October 2020  
Central Valley Ag Group Bulk Whole Cottonseed Transload Facility

# Final Initial Study/Mitigated Negative Declaration for the Central Valley Ag Group Bulk Whole Cottonseed Transload Facility at the Port of Stockton

## Western Regional Climate Center Data 1992-2002

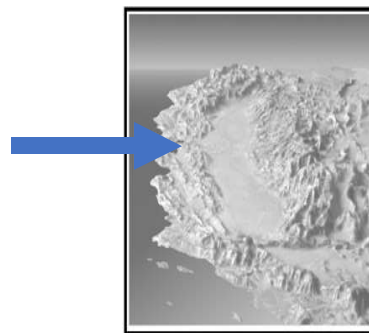
Data that conflicts with the description of prevailing winds has been obtained from two sources: Western Regional Climate Center<sup>6</sup> and the California Air Resources Board (CARB) air quality monitoring station located at Public Health Services on Hazelton Avenue in Stockton CA. The data from Western Regional Climate Center includes prevailing wind direction based on the hourly data from 1992-2002 obtained from the Stockton Municipal Airport (KSCK) and is defined as the direction with the highest percent of frequency.

The Sierra Club Delta-Sierra Group commented on discussions related to prevailing winds. As noted in Section 3.3.3.1.1 of the Draft IS/MND, the discussion of wind direction is specific to the regional setting and is correct as described. As no dispersion modeling was warranted, wind direction was not considered in the analysis completed for the impact determination. Therefore, no changes to the information presented in the Draft IS/MND are required.
